Title: Implications of Shared Channel Concept in TDD on the Iub

Source: Siemens, Italtel

Agenda Item: 13.2 (UTRAN Iub Interface: General Aspects and Principles – Procedure specification)

Figure 2: Logical Model of NodeB for TDD

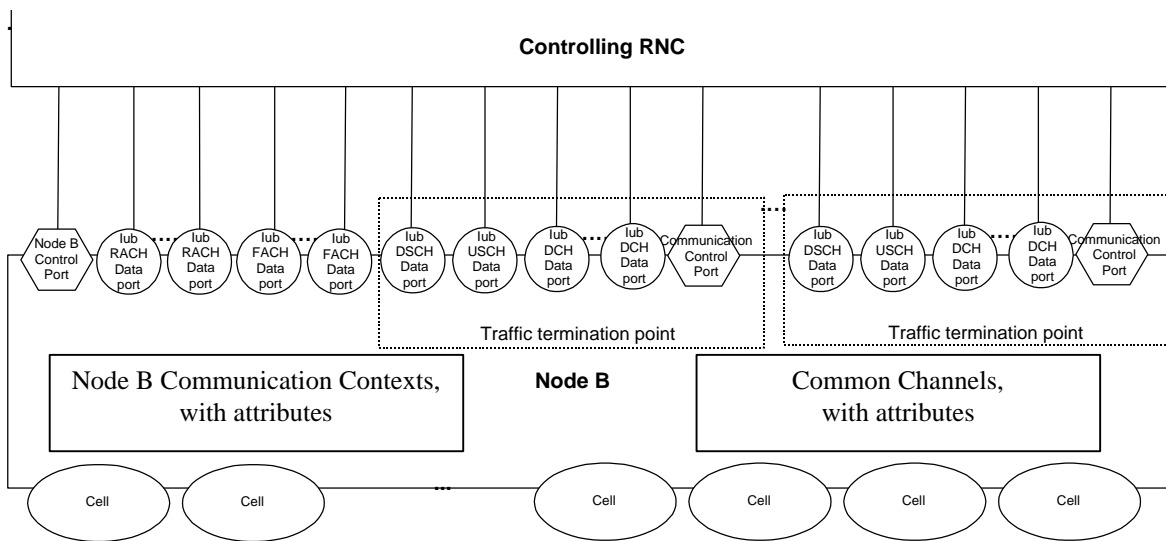
Figure 2 above shows an amended logical model of NodeB for TDD shared channel operation. This illustrates the single USCH and DSCH per cell.

1. Section 6.1 'Overview', the text and/or title of the existing figure 'Logical Model of Node B' should be amended to state that this is for FDD only
2. Section 6.1. 'Overview', the figure 2 'Logical Model of Node B for TDD' from this document should be included
